Project Name: UNIVERSITY OF CALIFORNIA, MERCED
LITTLE LAKE AMPHITHEATER UPGRADE
Project No.: 907075

ADDENDUM NO. 2
to the
CONTRACT DOCUMENTS
August 26, 2013

6 CONCRETE JOINTS
NTS

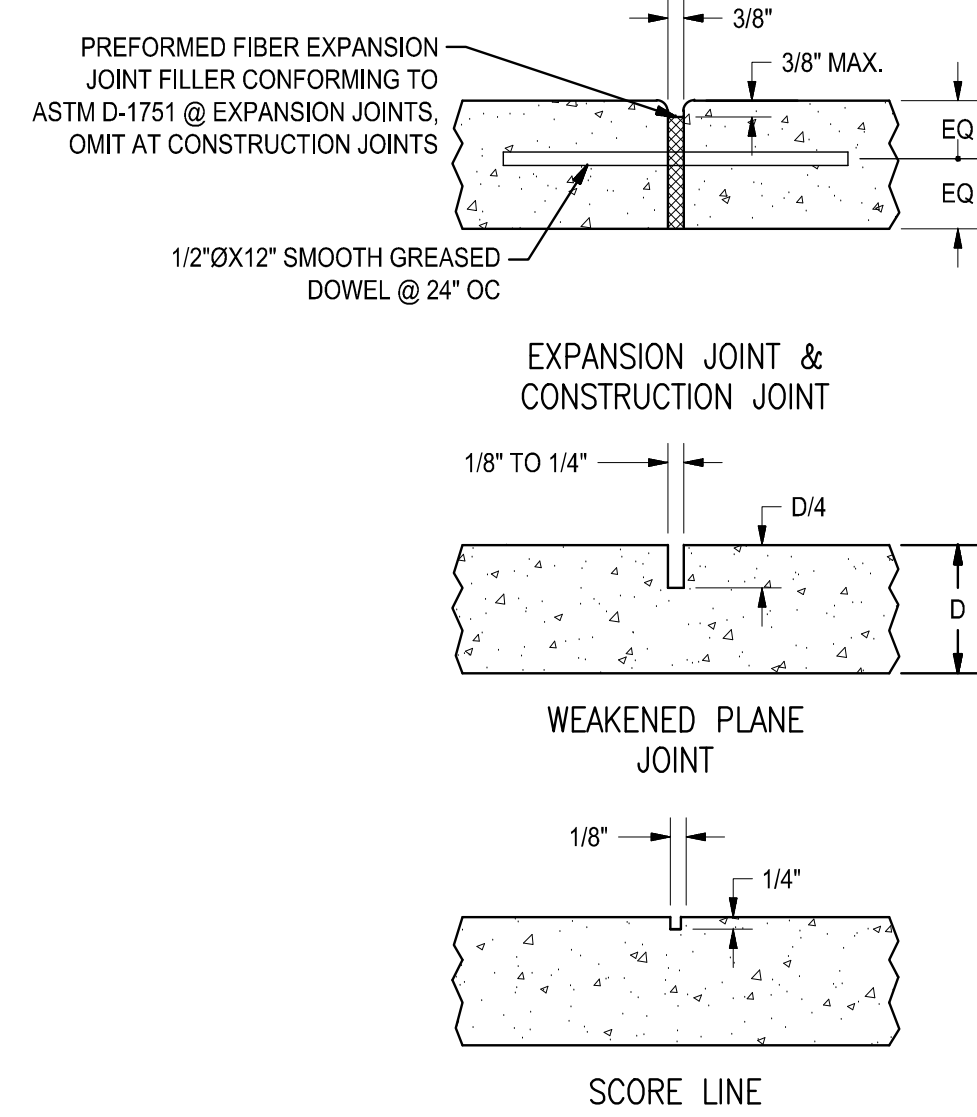
9. Q. Provide soils report and recommendations for compaction.
 - A. Condor Nuclear Density Testing Field Reports included in this Addendum.
10. Q. Clarify location of joint sealants.

- A. Expansion Joint sealant shall be in accordance with specification section 32 13 13 2.4E and 32 13 13 3.9C. Revise Detail 6/C5.0 to indicate joint sealant at expansion joints.

7 6\"/>

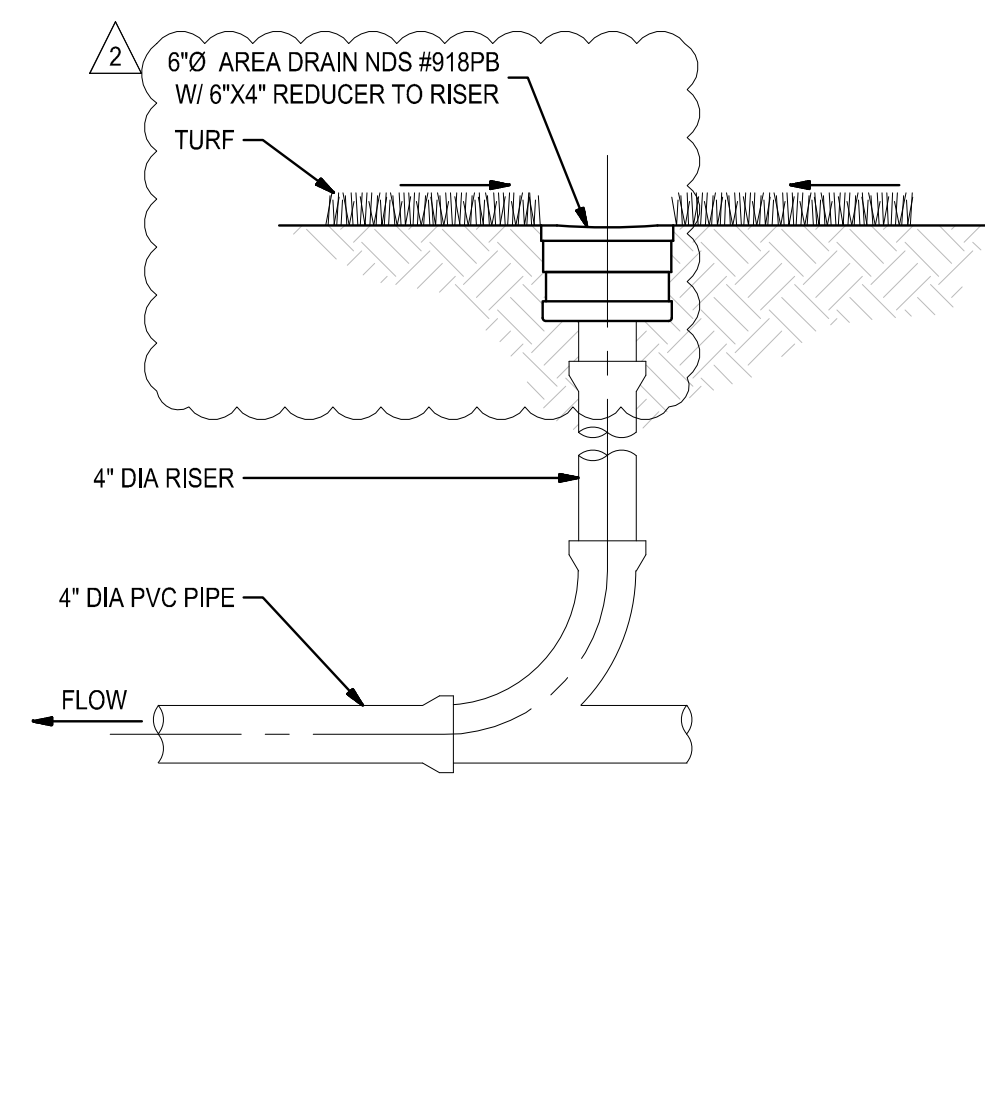
3. Q. Please confirm SWPP, WDID & NOI by UC Merced.
A. University will implement, maintain and remove any and all requirements for SWPP, WDID & NOI.
 4. Q. Provide the specification for the area drain per detail 7.

A. Detail 7/C5.0 is revised to include the specifications for the area drain; 6" diameter area drain NDSH#918PB with 6" x 4" reducer to riser.
 5. Q. Please provide the detail for surface mounted fixture in concrete walk way.

14 RETAINING WALL DETAIL
NTS

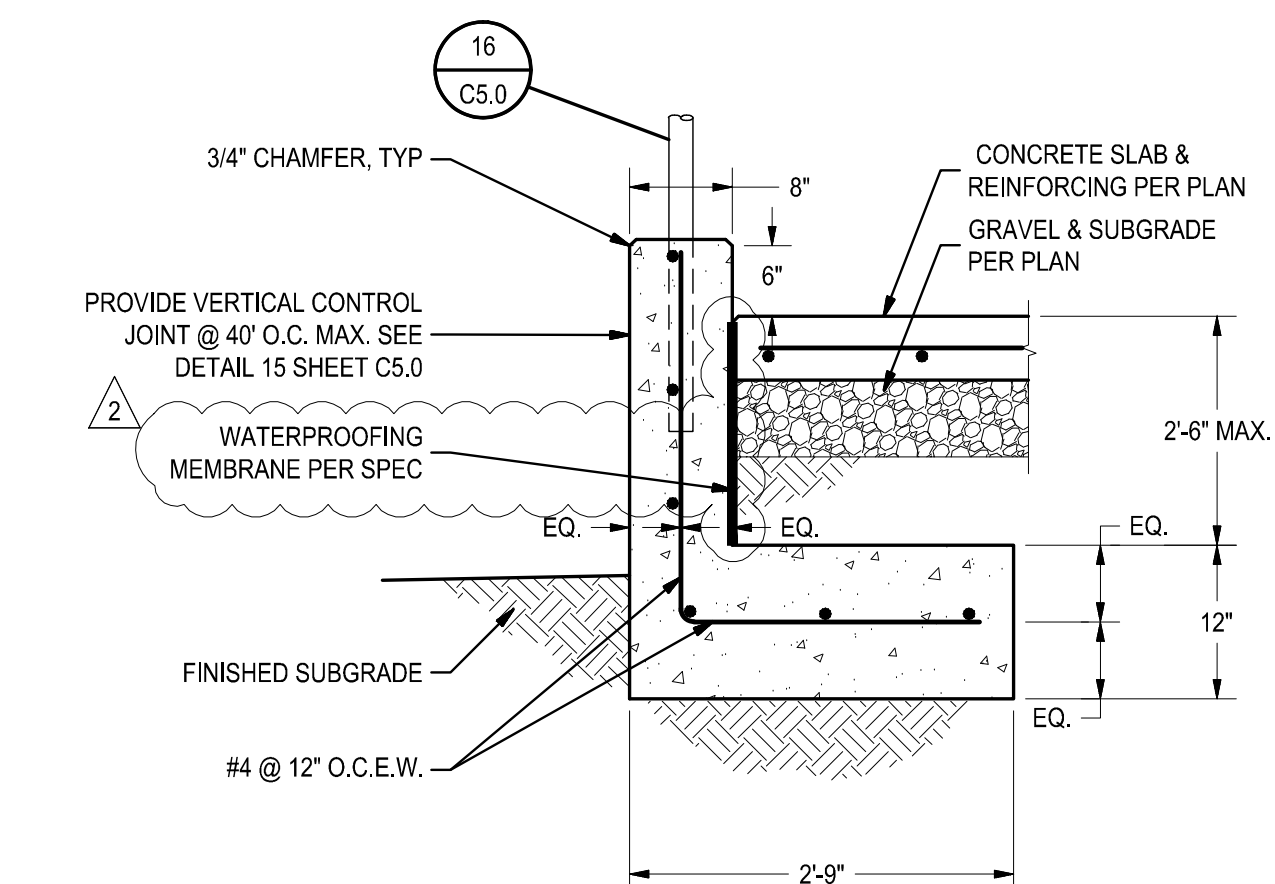
A. All concrete shall be per the concrete specifications, 3500 psi @ 28 days.
 7. Q. Provide application location for damp proofing Tremproof 60 per specification section 32 23 23.

A. Detail 14/C5.0 is revised to indicate the location of the below grade waterproofing identified in the specifications.
